Vermont Agency of Transportation

REQUEST FOR PROJECT REVIEW

Proj. Name and Number: Middlebury WCRS(23)

CONTRACT 1
FINAL PLANS
OCTOBER 2016

PROJECT NAME: MIDDLEBURY	
PROJECT NUMBER: WCRS(23)	
FILE NAME: z10g044bdr_nul_util_pl.dgn	PLOT DATE: 10/18/2016
PROJECT LEADER: A.P. GUYETTE	DRAWN BY: K.D. WENTWORTH
DESIGNED BY: M. KEENE	CHECKED BY: P. SMIAR
DRAINAGE LAYOUT SHEET	SHEET 68 OF 116

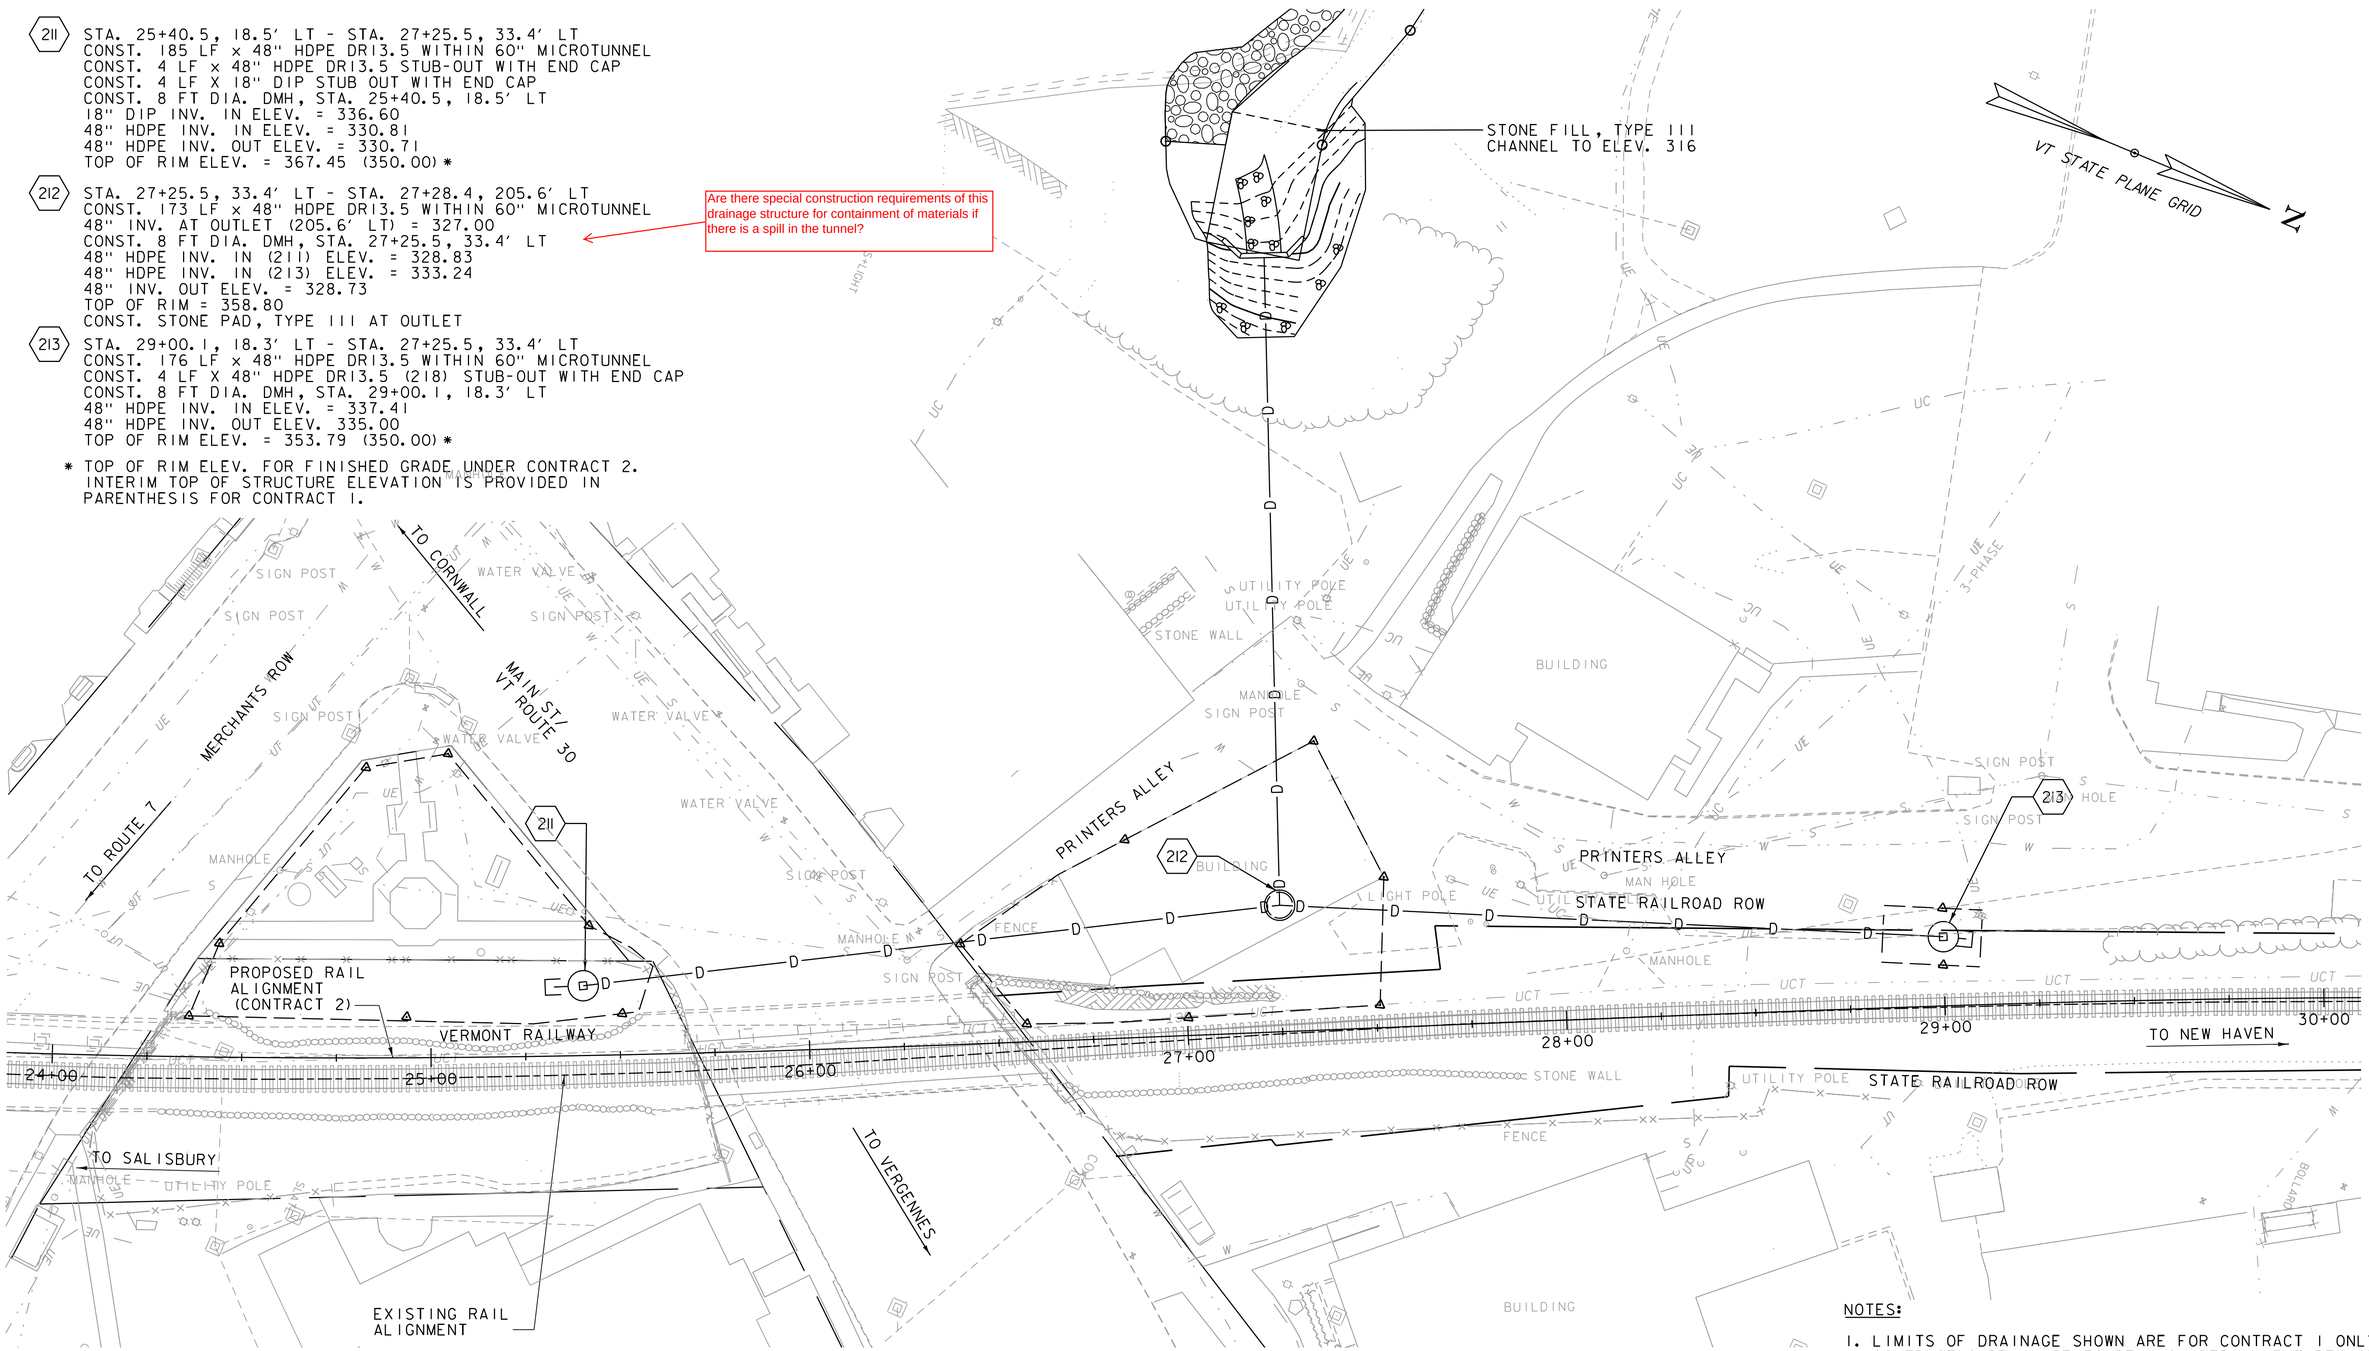
Are there special construction requirements of this drainage structure for containment of materials if there is a spill in the tunnel?
